UNITED STATES PATENT AND TRADEMARK OFFICE

Office Action Summary

10/567,891

DETAILED ACTION

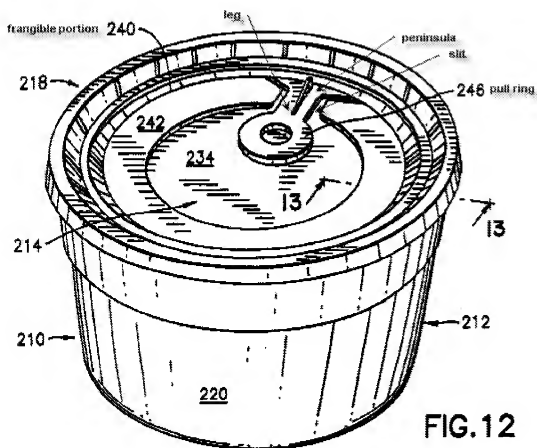
10. Claims 10, 11, 14, 20 and 21 are rejected under 35 U.S.C. 102(b) as being anticipated by Farrell et al. (US 5,692,635). See figures 12 and 13 and column 8, lines 43-48. Figure 12 is re-produced below and labeled as per the examiner's interpretation of the claim language. The

FIG. 13

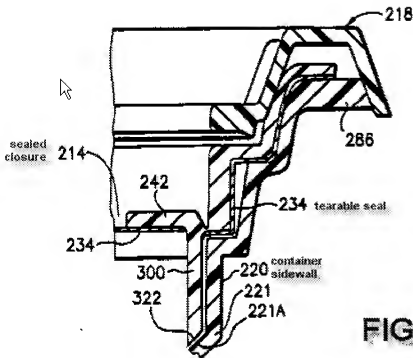
tearable seal (234) is seen in figure 13.

Regarding claim 14, the seal is weldable on both sides although it is not welded to the container.
